X 96.004-26

Model 232, 235

Muffler

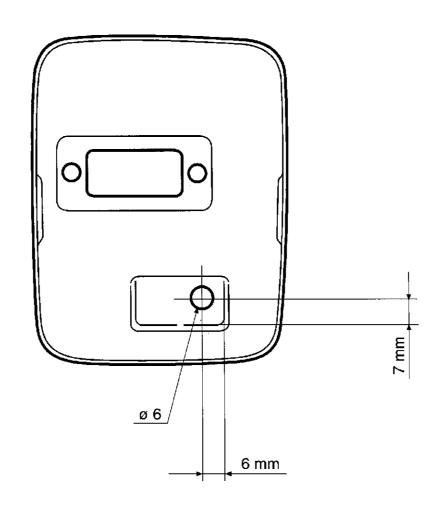
In those cases where there have been problems with the muffler's mounting bolts becoming loose or shearing off, a third mounting bolt can be fitted. This is possible on machines manufactured in 1995 and later (serial number 501 xxxx and higher), which have cylinders with three mounting holes for the muffler.

One hole with a diameter of 6 mm is drilled in the inner muffler half 502 19 98-01, as shown in the diagram below. The bolt MC 6S 5x16, reference number 725 53 29-55, can be used for mounting.
